CITY OF KIRKLAND
Planning and Building Department
123 Fifth Avenue, Kirkland, WA 98033
425.587.3600 www.kirklandwa.gov

To: Design Review Board
From: Tony Leavitt, Senior Planner
Date: September 9, 2016
File No.: DRV16-01412
Subject: **VAREZE RESIDENTIAL PROJECT
DESIGN RESPONSE CONFERENCE**

site plan presented on 5/16/16

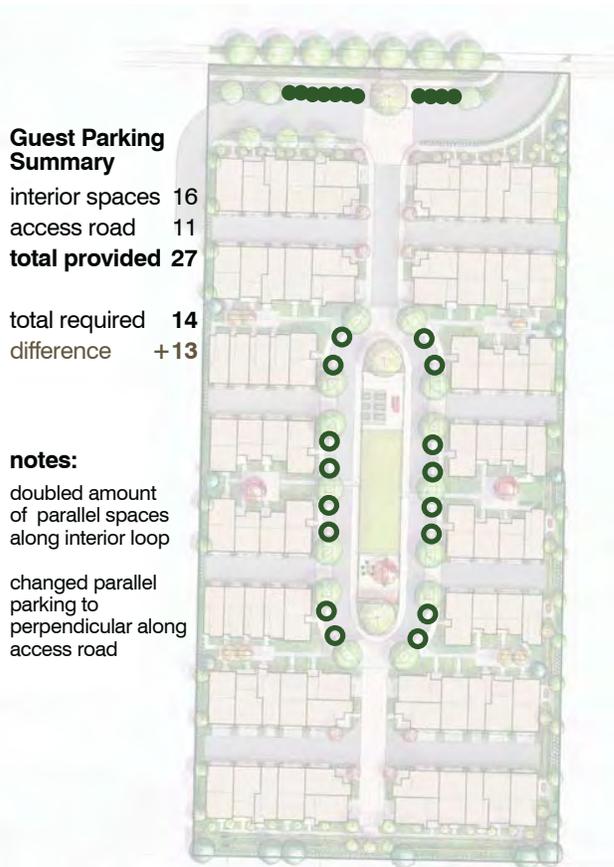
The DRB expressed a preference for massing Plan 1. Plan 1 included a large central park with most of the buildings surrounding it. The DRB requested the following items for submittal:

- Various site sections across the property including a roadway section that incorporates the park, fire lane, sidewalks and parking.
- Modifications to the site plan including exploring designs that make the access roads and buildings less linear. Consider pavers and greenery in auto courts to lessen their impact.
- Human scale elevation plans of the buildings including roof structures and articulation details.

As requested by the DRB, the applicant has provided detailed plans of Plan 1 for review (see Attachment 2).
